## Applicable Urban Design Priorities that Project Should Achieve

# Forest Theater

City of Dallas Urban Design Peer Review  
September 27th, 2024

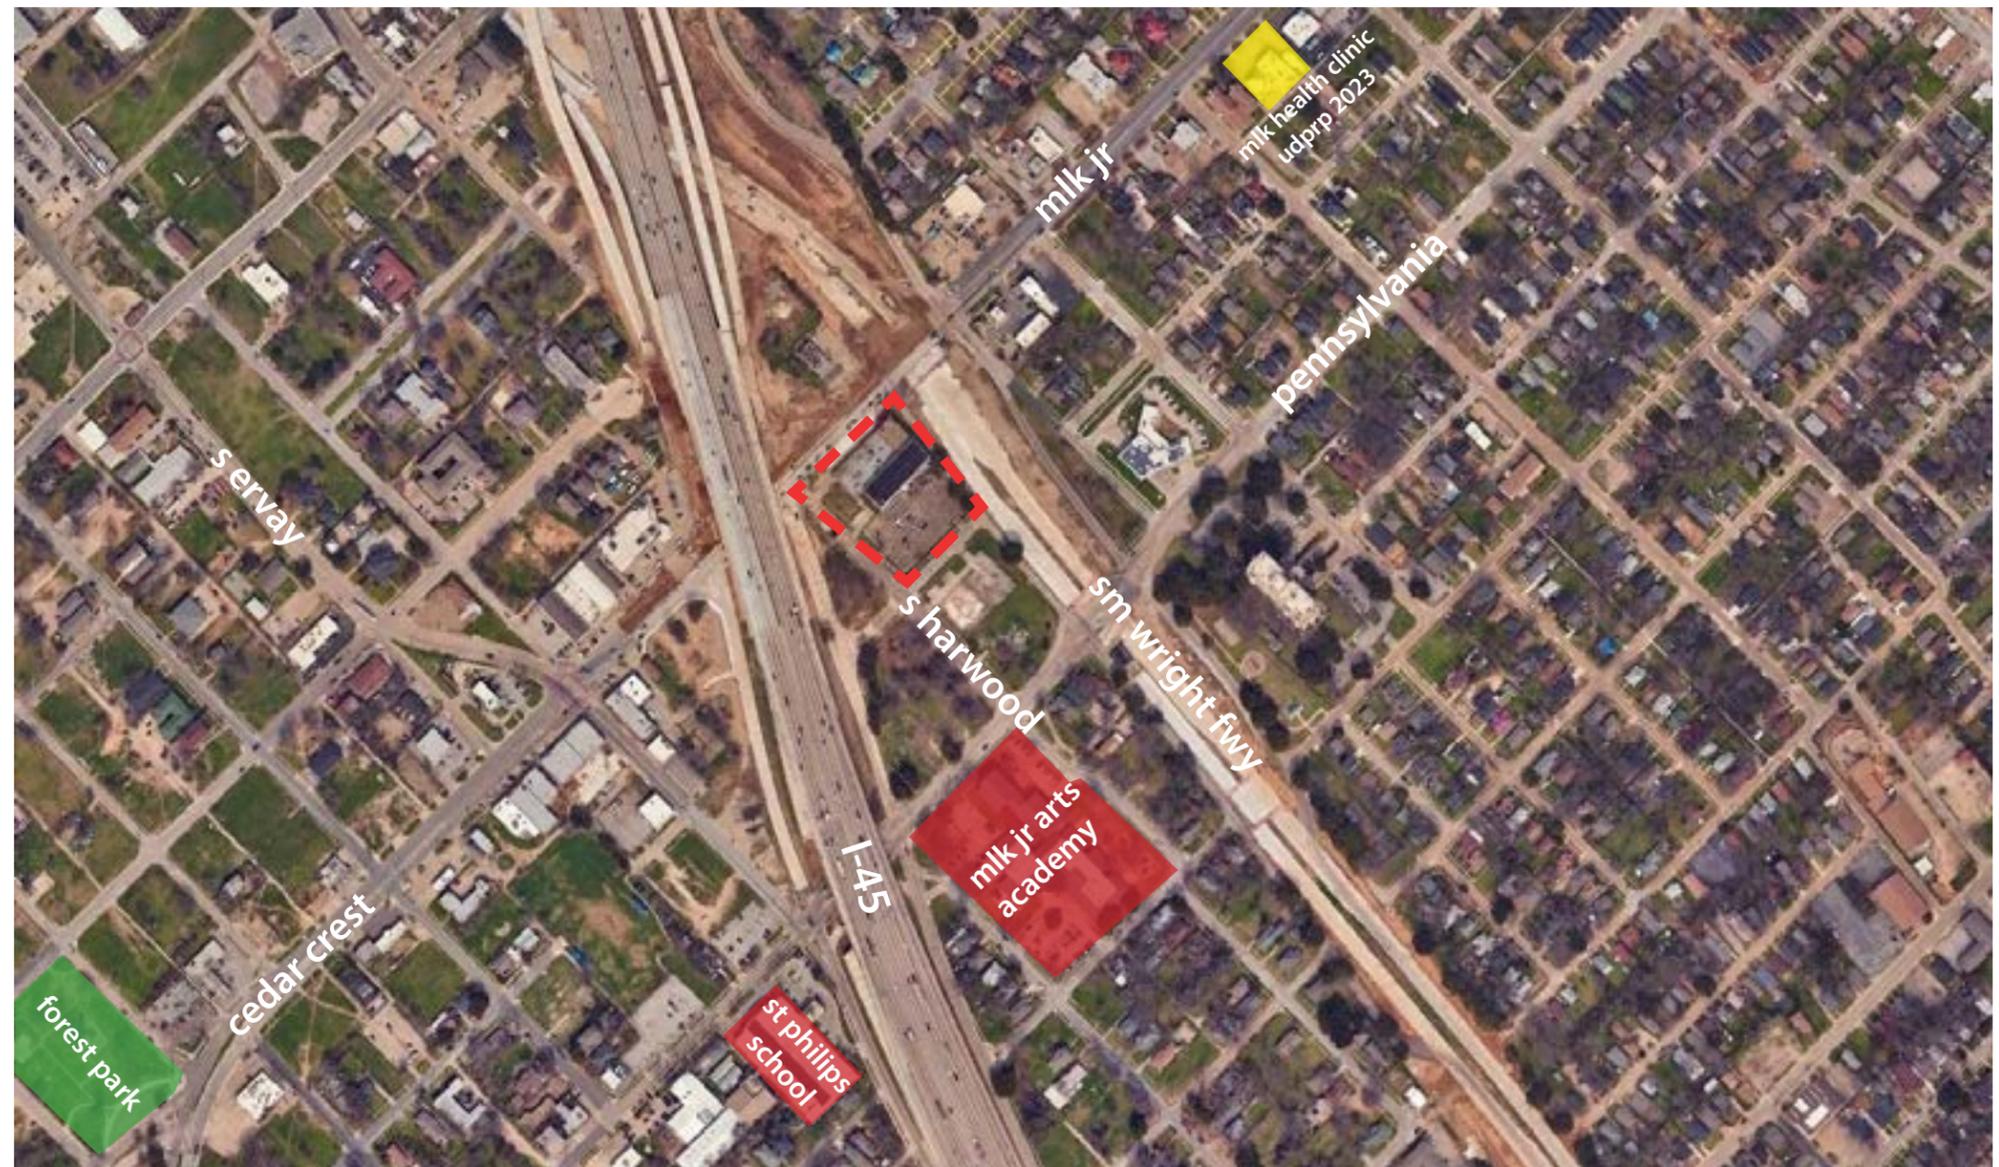
**[1] Parking, although a necessary element, may not directly support the pedestrian and active streetfront environment.**

Explore opportunities to reduce the overall number of parking spaces and/or adjust on and off-site vehicle circulation. The goal should be to allow for as much landscaping, programmatic open spaces, and opportunities to invite all users directly and safely to the Forest Theater campus. Ensure that visitors can safely access campus from proposed parking underneath I-45.
